## Comments on Draft S-52 PL Edition 4.0.3

From: "Sazhnov, Nikolay" <nikolay.sazhnov@wartsila.com>

**ECDIS Chart 1 symbols**

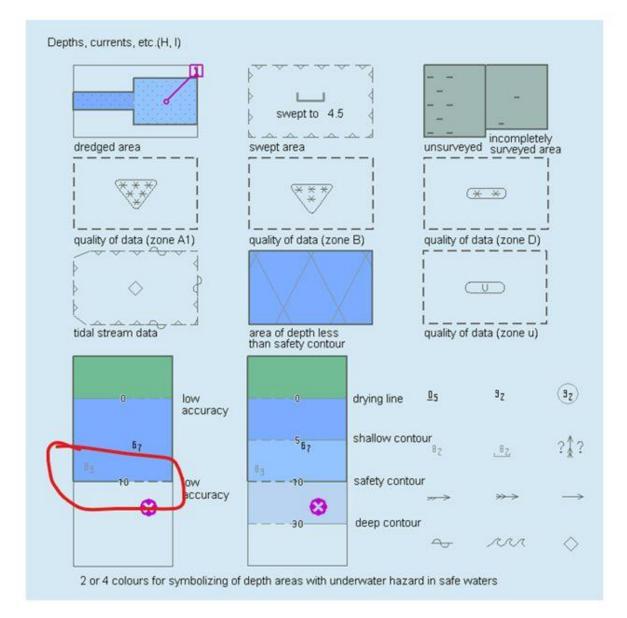
However, on the general picture of ECDIS Symbols the depth contour still retain 30 m. See below picture (H,I).
